**TITLE:** Notification that – ISO/IEC 14443-3:2010/FDAM4 - Identification cards - Contactless integrated circuit(s) cards - Proximity cards - Part 3: Initialization and anticollision - AMENDMENT 4: Electromagnetic disturbance handling and single size UID – has been posted to the ISO server for FDAM ballot

**ISO/IEC 14443-3:2010/FDAM 4:2010(E)**

**AMENDMENT 4: Electromagnetic disturbance handling and single size UID**

**Figure 1 — Frame delay time PCD to PICC**

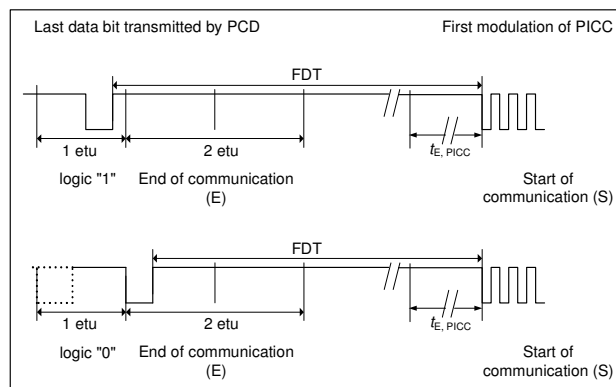
Replace Figure 1 with the following figure and add the note after Figure 1:

"NOTE  $t_{E,PICC}$  is specified in clause 8."

Figure 17 — Timing before the PICC SOF

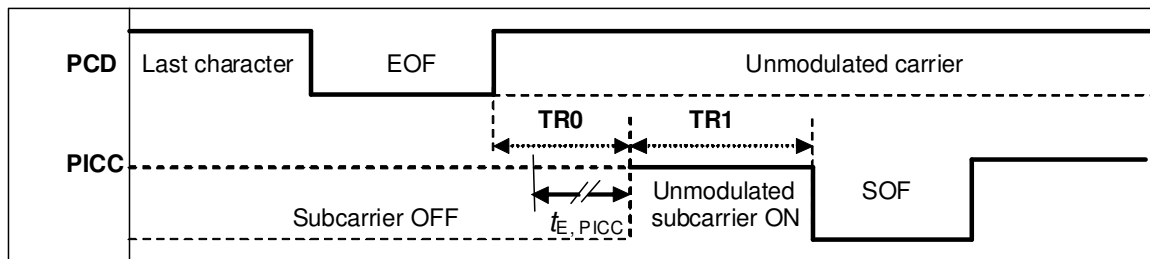
Replace Figure 17 with the following figure and add the note after Figure 17:

"NOTE  $t_{E,PICC}$  is specified in clause 8."

Figure 33 — Low EMD time

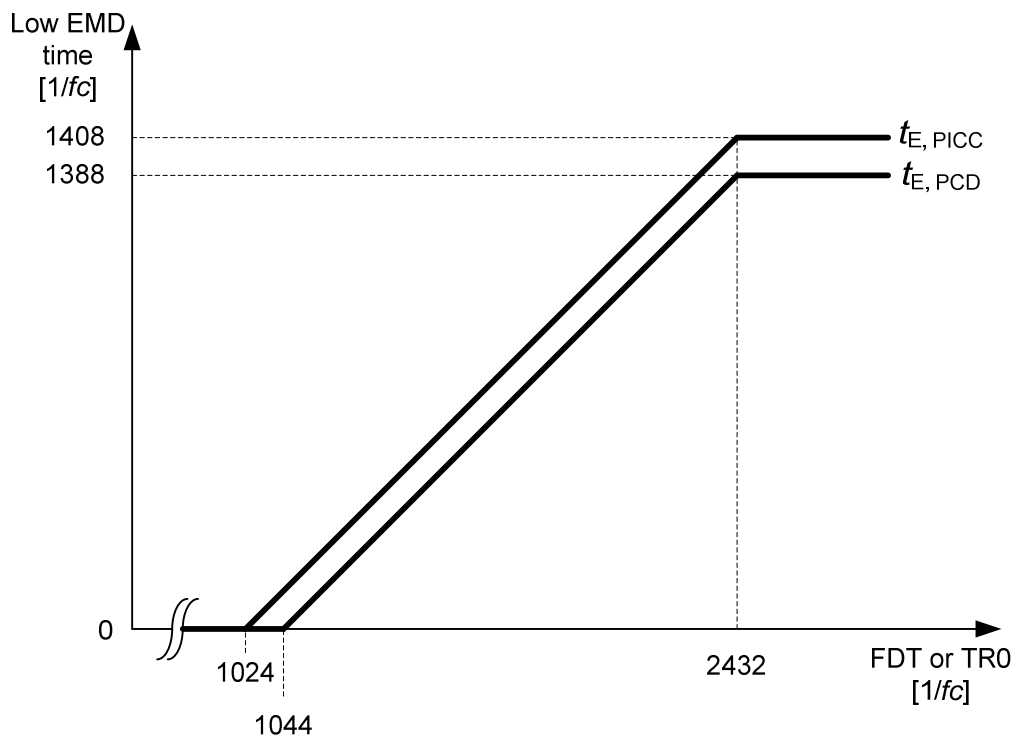
Insert the following new clause 8 after clause 7:

The low EMD time for PCD and PICC are illustrated in Figure 33.

The low EMD time  $t_{E,PICC}$  is the time period before the start of PICC data transmission, when the PICC shall not produce an EMD level higher than the EMD limit as defined in ISO/IEC 14443-2/Amd.3.

This low EMD time  $t_{E,PICC}$  has a value of  $F - 1024/fc$  with a maximum value of  $1408/fc$  where  $F$  equals FDT for Type A and TR0 for Type B. The value is  $0/fc$  for  $TR0 \leq 1024/fc$ .

The low EMD time  $t_{E,PCD}$  is the time period to allow the PCD to recover from electromagnetic disturbances.

The PCD shall be ready to process a PICC frame no later than  $t_{E,PCD}$  after the last time the EMD level was above the EMD limit as defined in ISO/IEC 14443-2/Amd.3.

This low EMD time  $t_{E,PCD}$  has a value of  $F - 1044/fc$  with a maximum value of  $1388/fc$  where  $F$  equals FDT for Type A and TR0 for Type B. The value is  $0/fc$  for  $TR0 \leq 1044/fc$ .
